SS 1033638 - Power Window Express Down Module Discontinued

Cascadia, Columbia, Century Class, Argosy, and 24U

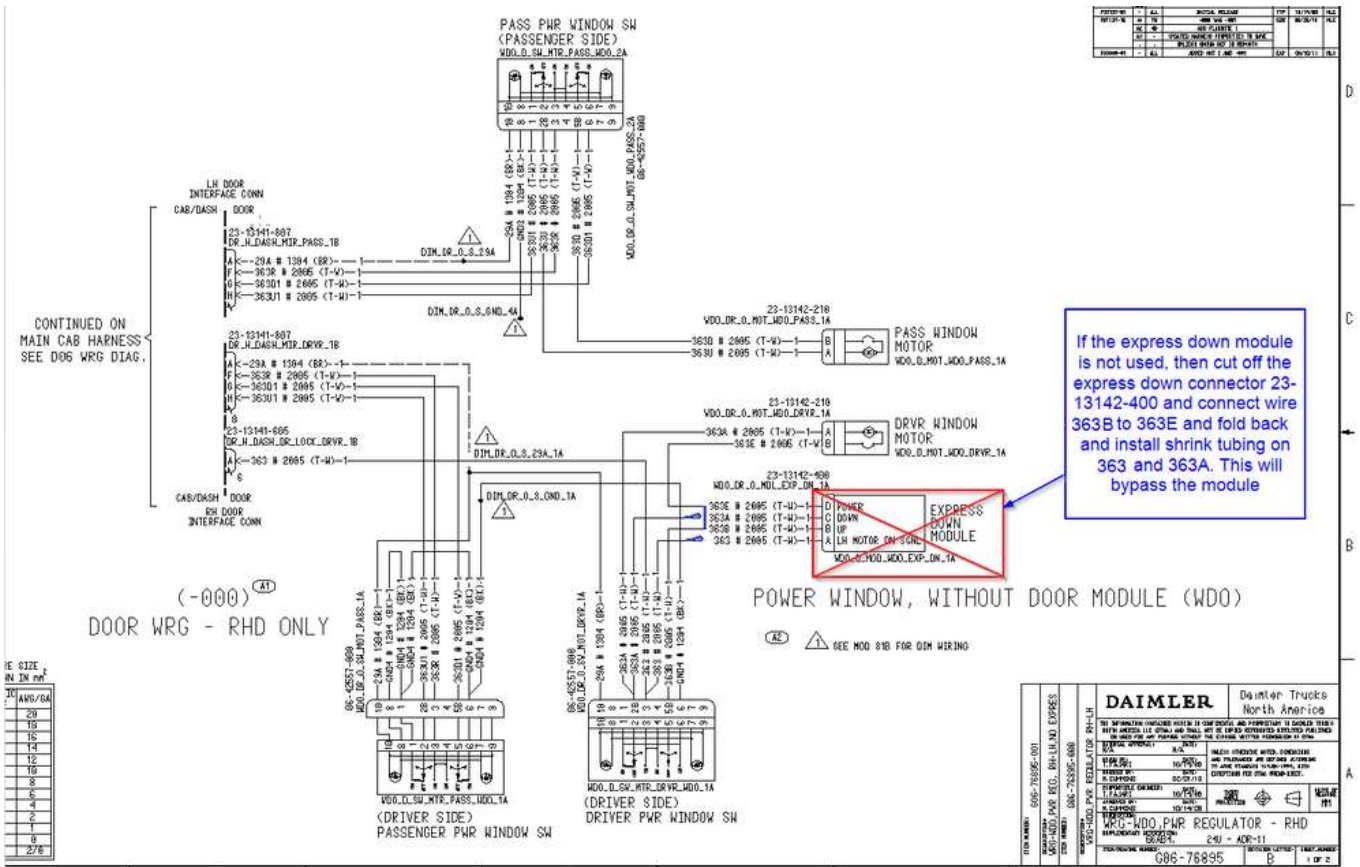
"Express Down" feature which was used with electric windows to lowered the drivers window when the down switch is depressed one time has been discontinued, and the Express Down Module located in the drivers door is no longer available.

Since it is no longer available, if the Express Down Module has failed, the solution is to remove the module and modify the wiring for the electric window as noted in the diagram below. Making this modification *will allow the window "up / down" to function normally, only without the express down feature.*
